RE: BENNETTS GREEN BUNNINGS AND BULKY GOODS DEVELOPMENT

1. As requested, we are writing regarding matters raised by council and RMS in relation to the above development. We have previously prepared a report¹ which was submitted with the development application.
2. The council email of 27 September and RMS letters of 26 October 2017 include a number of traffic and parking matters. In response to the matters raised, amended plans have been prepared by the project architect. These matters, and our responses, are set out below.

**19.0m ARTICULATED
 VEHICLE SWEPT PATHS**

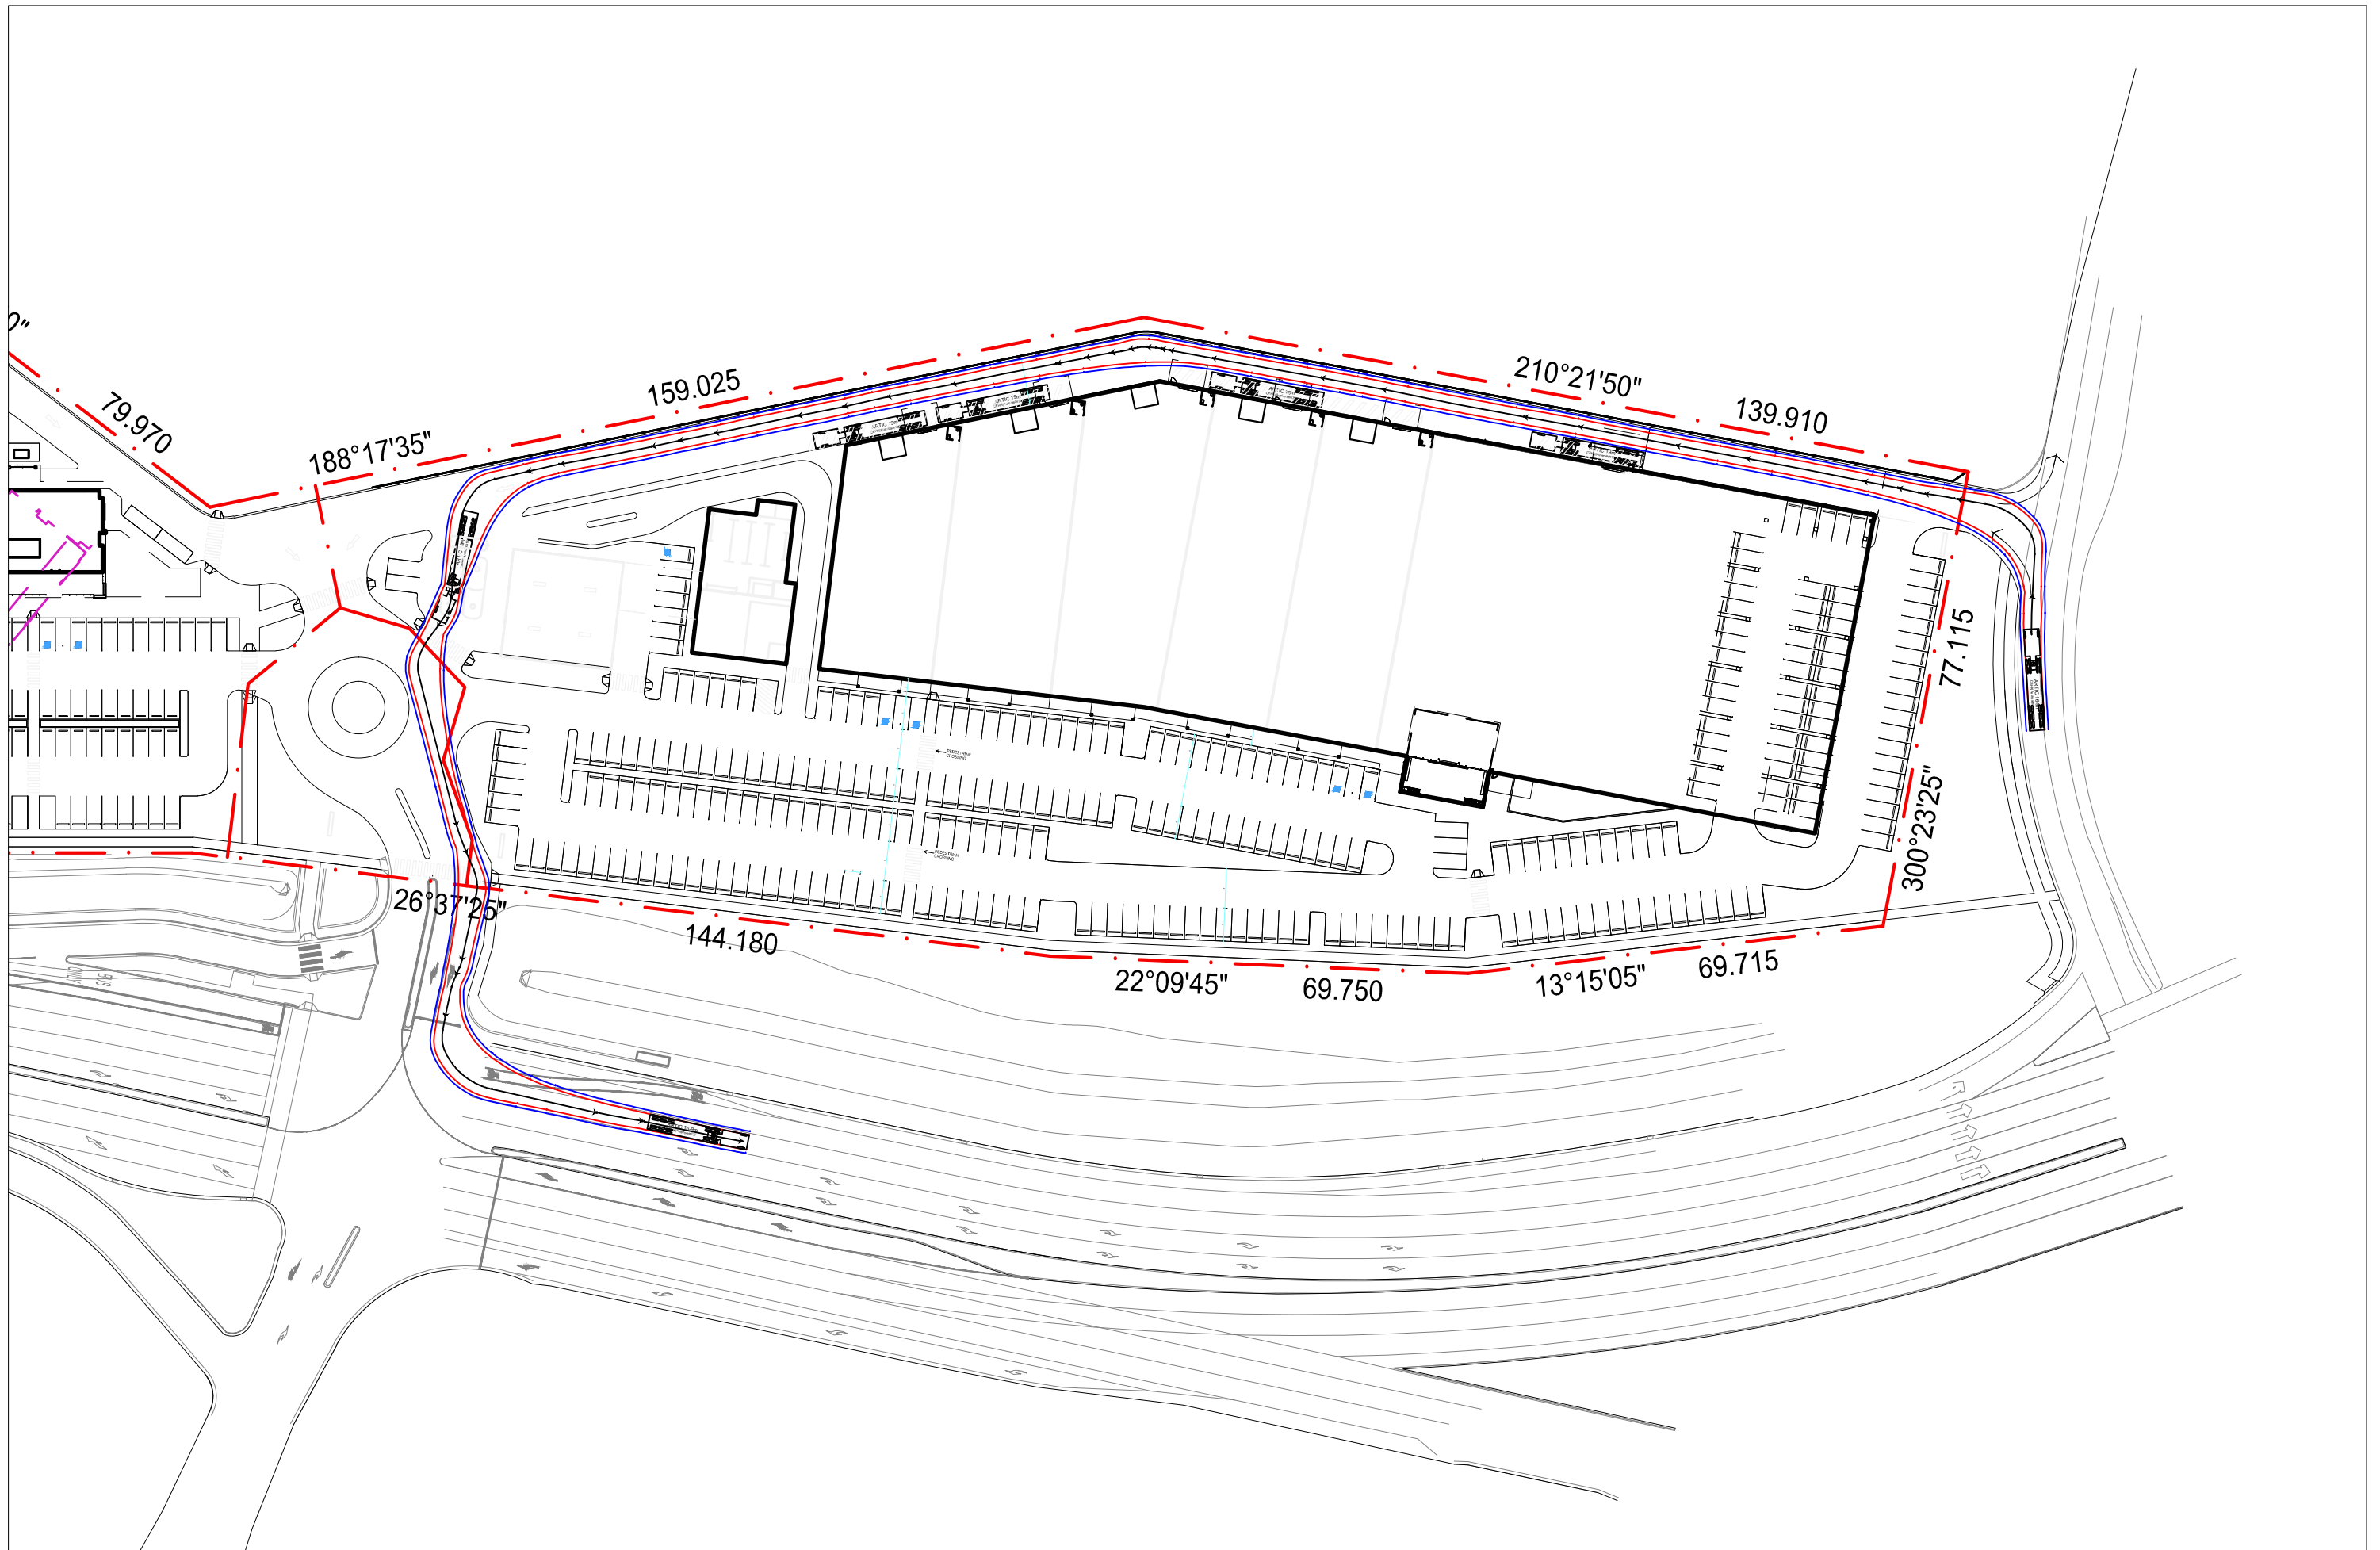
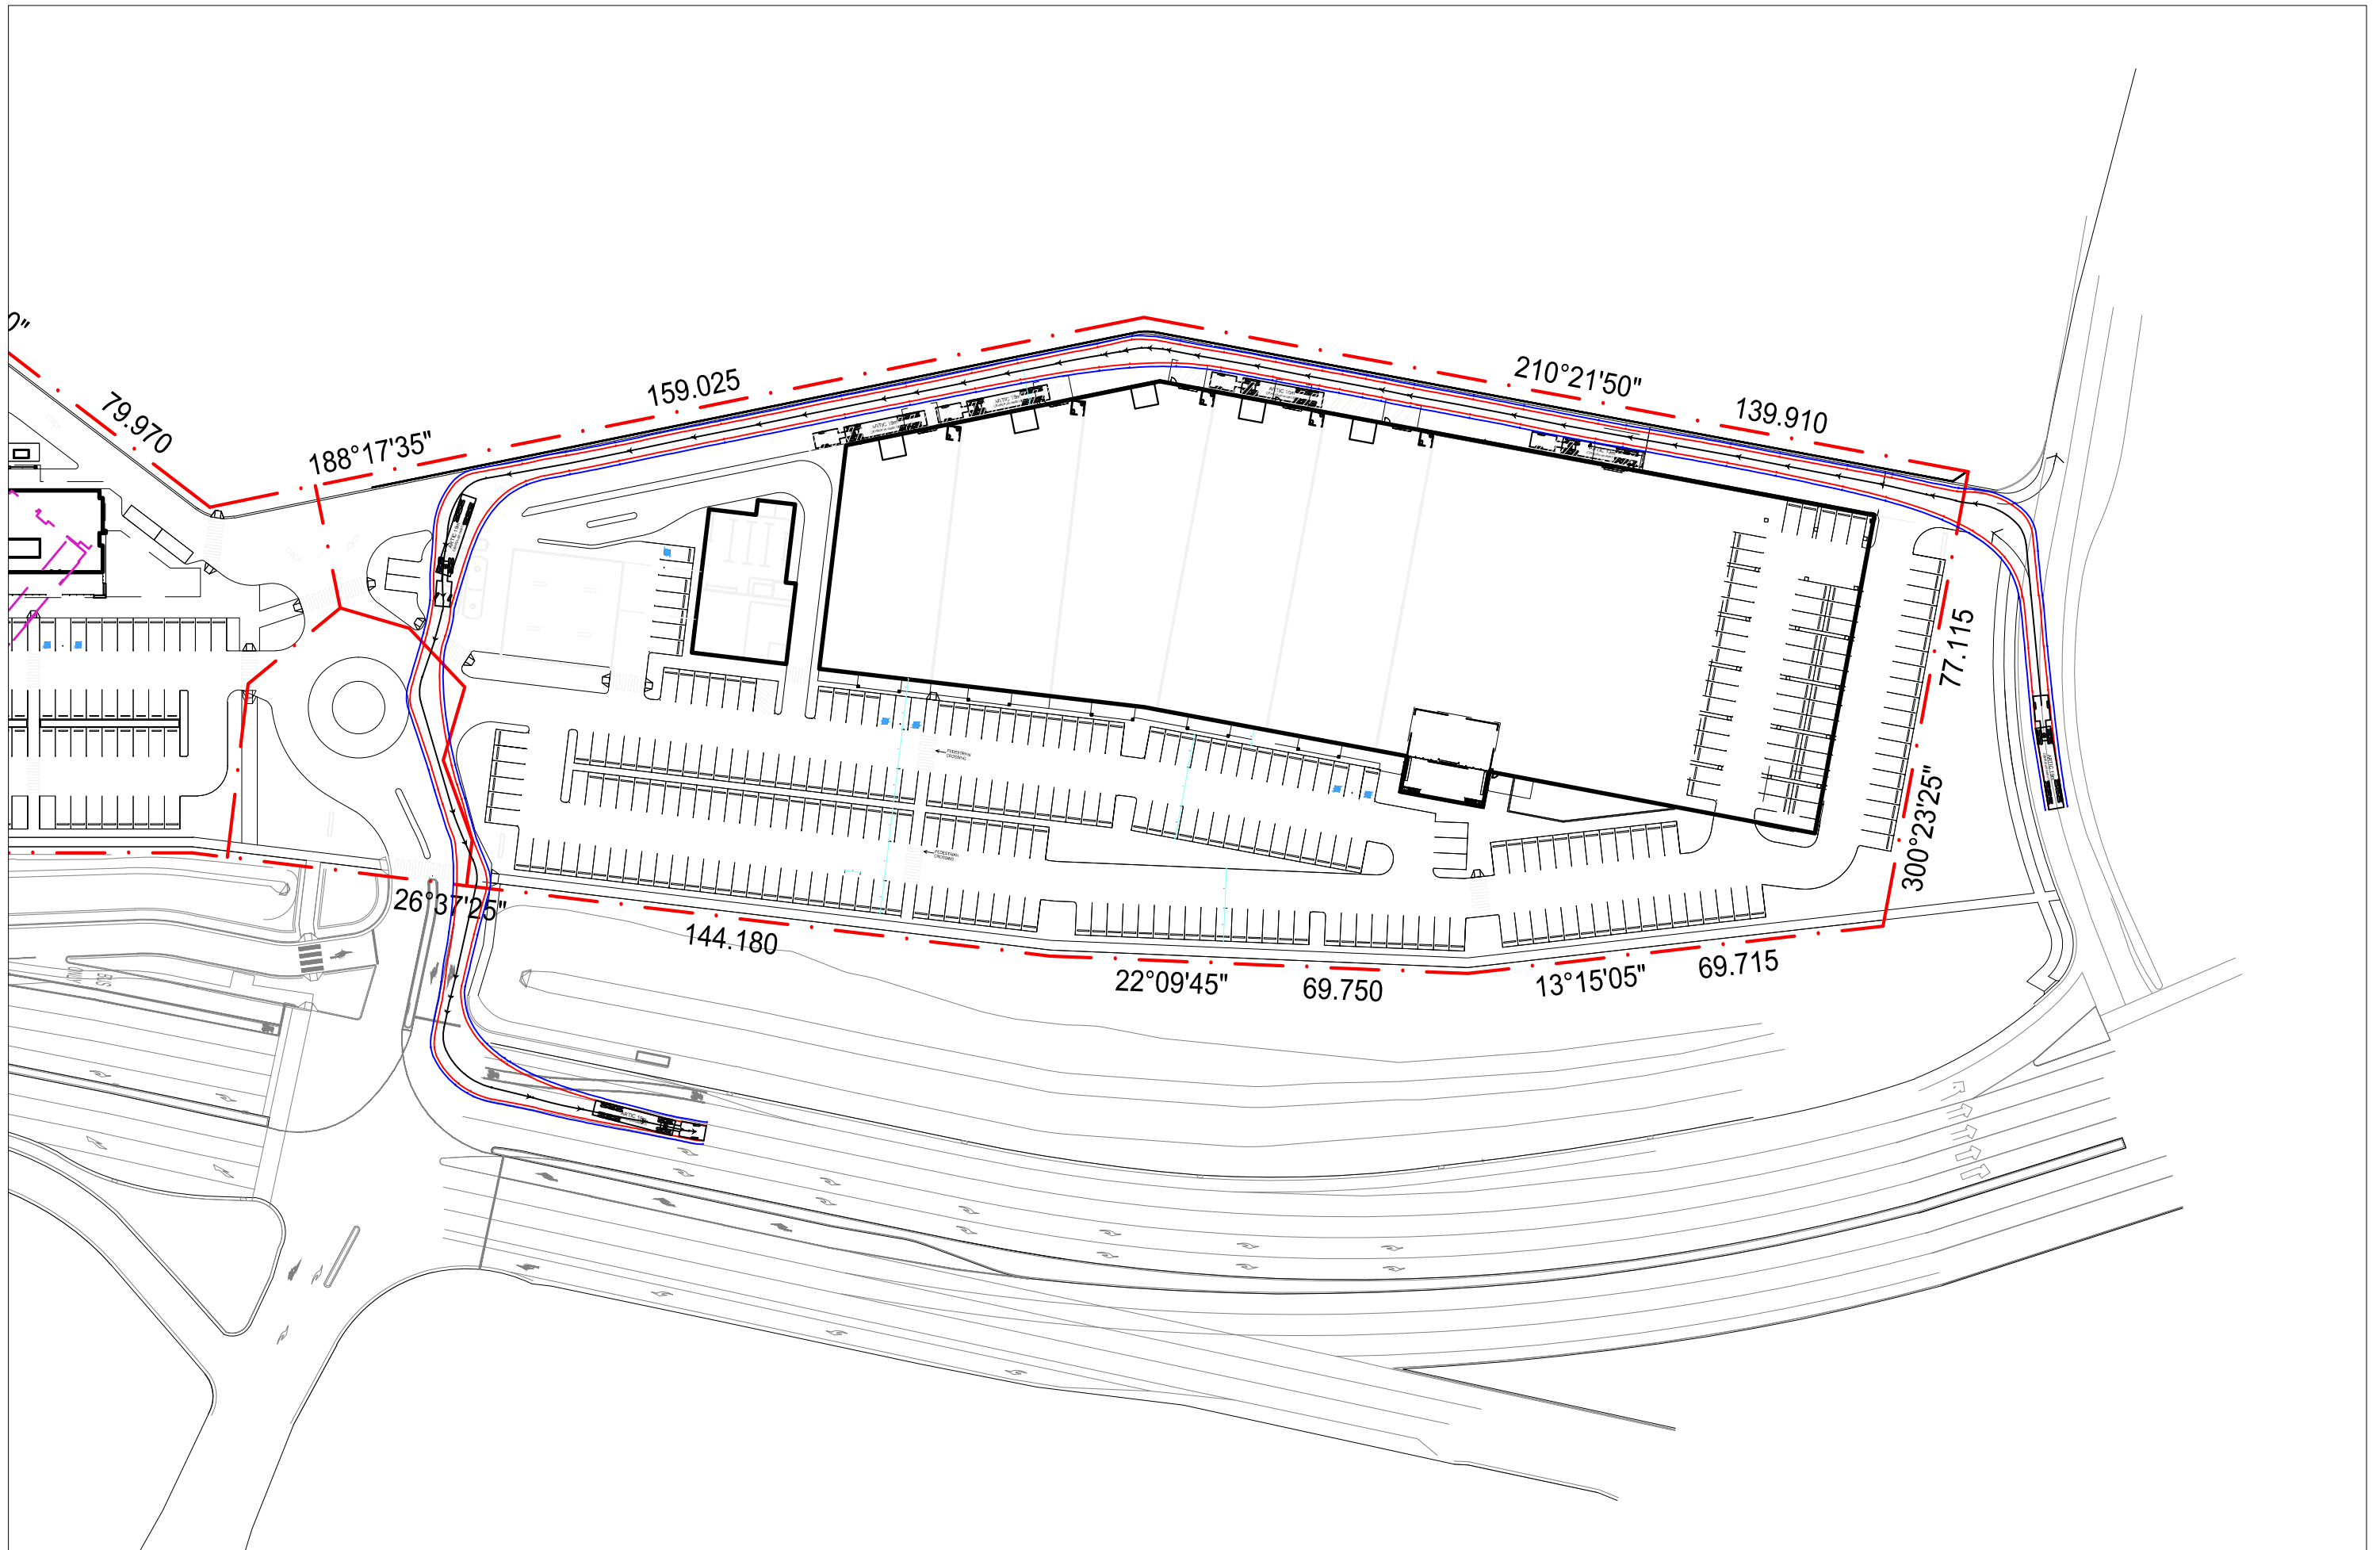
6. The proposed arrangements are therefore considered to be appropriate.
 - *Building Products Warehouse and Showroom*
 - 1) *The access ramp/driveway from South Street to the rear service bay of the Building Products Warehouse and Showroom requires additional detail in the form of widths, clearances and the like, inclusive of swept paths from South Street, through the access ramp and within the service delivery bay...*

- *Servicing*
 - 1) *Details of service vehicles including swept paths are required for internal areas (deliveries and waste collection) for the Building Products Warehouse & Showroom as well as the Bulky Goods Units and Restaurant. Additionally movements at the (Bunnings service vehicles) South Street and the Pacific Highway access points are to be provided.*

- *Details for servicing (deliveries & waste collection) the development are required in terms of manoeuvring/swept paths.*

7. Vehicle swept paths are attached to this letter as Figures 1 to 12.
 - *Parking*
 - 1) *The development provides a total 846 car parking spaces, 13 additional non-discriminatory parking spaces and 2 waiting bays. An assessment based on the proposed GFA identified 697 car parking spaces and 14 non-discriminatory parking spaces as being required. Therefore as an excess in car parking is proposed a reduction is required as per Council's DCP and to improve landscaped outcomes.*

21. Service vehicle swept paths are shown in Figures 1 to 12.

- *The plans are ambiguous as to how vehicles will access the Take Away Food & Drink Premises. It appears vehicles are required to access the drive thru via the entrance of the Service Station, which could become quite congested considering queuing for petrol bowsers. Details are required on how vehicles will access the drive thru and what will prohibit these vehicles travelling on the Service Road in the opposite direction to Service Vehicles.*

16. Vehicles will enter this drive-through from the service station, in a similar manner to many other service station/fast food developments. The swept paths attached in Figure 12 show that with two vehicles queued at the petrol bowers, other vehicles will be able to readily circulate to the drive-through.
17. There will be appropriate no entry signage at the western leg of the roundabout, which will apply to service vehicles and general traffic.
